EL MONTE UNION HIGH SCHOOL DISTRICT

April 14, 2023

TO : All Bidders
FROM : El Monte Union High School District
BID # : 2022-23(B8)
PROJECT : Mountain View HS Modernization Project
SUBJECT : Addendum No. 2

1. LPA Architects Addendum No. A issued April 14, 2023 attached.

AJ-2.11

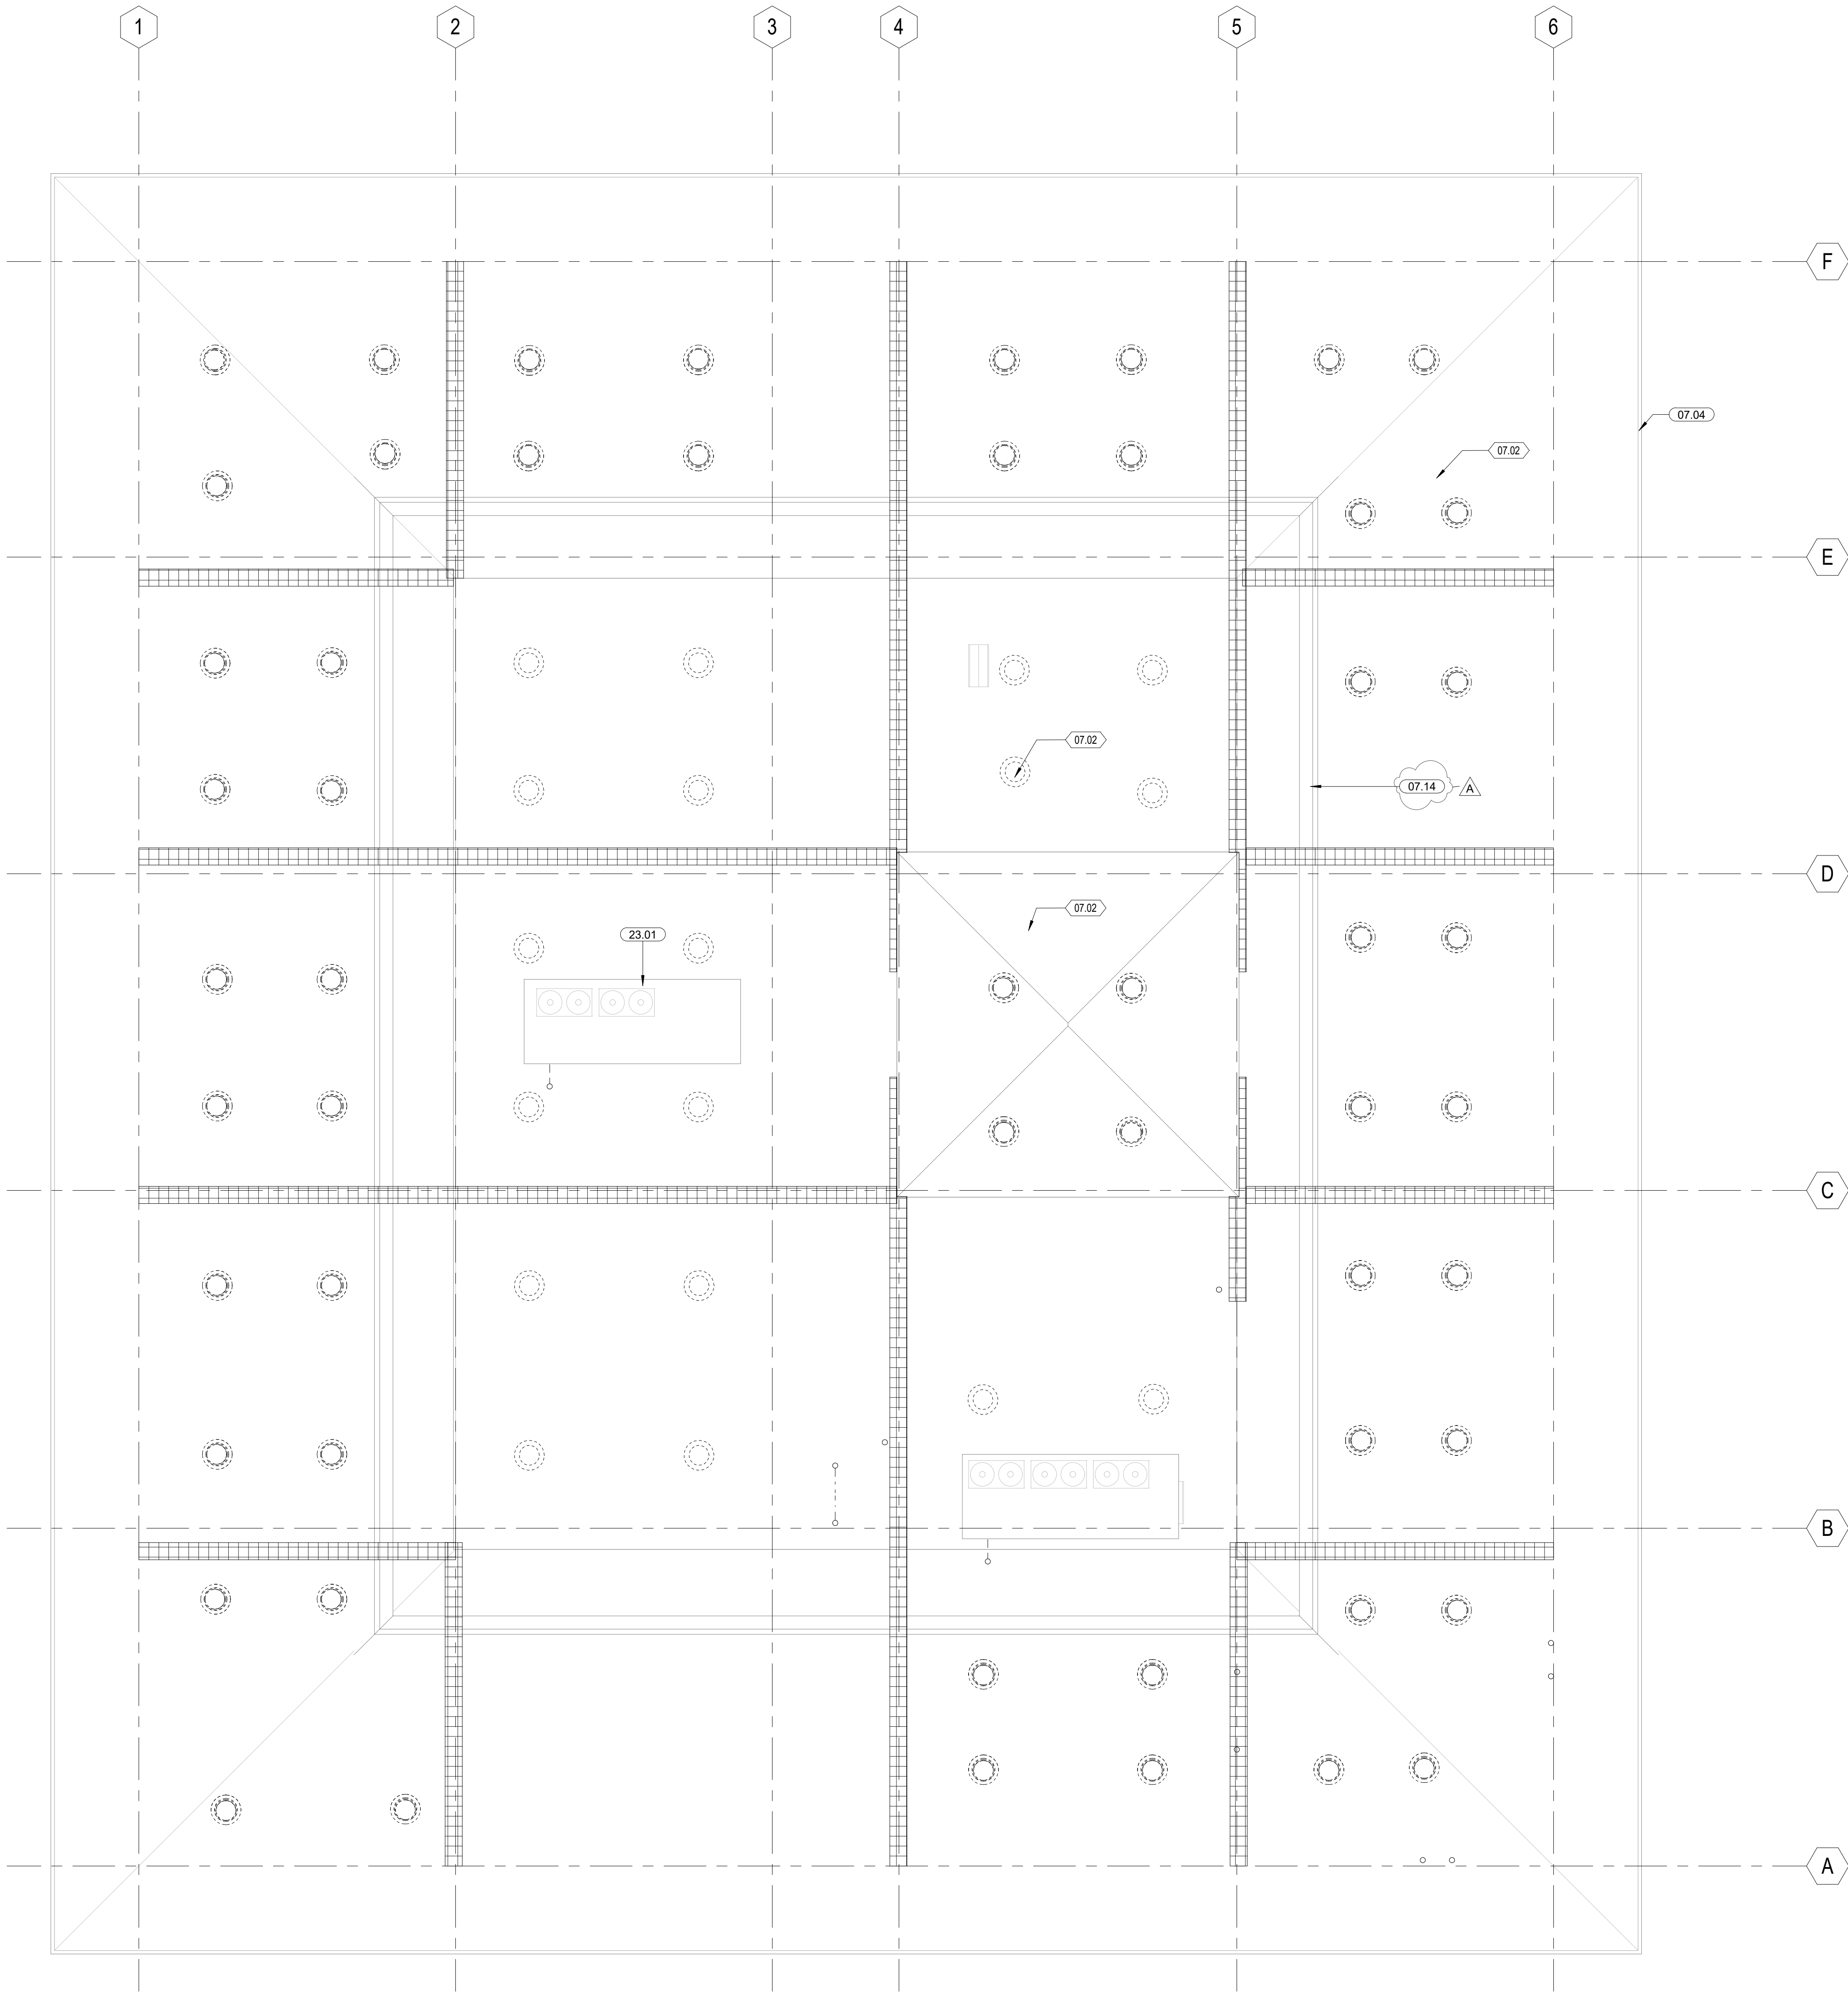
- Item No. 33** **Sheet AJ-2.11 – Reconstruction Floor Plan and Roof Plan**
(a) Revised keynote 07.06 to 07.14 for existing roof baffle
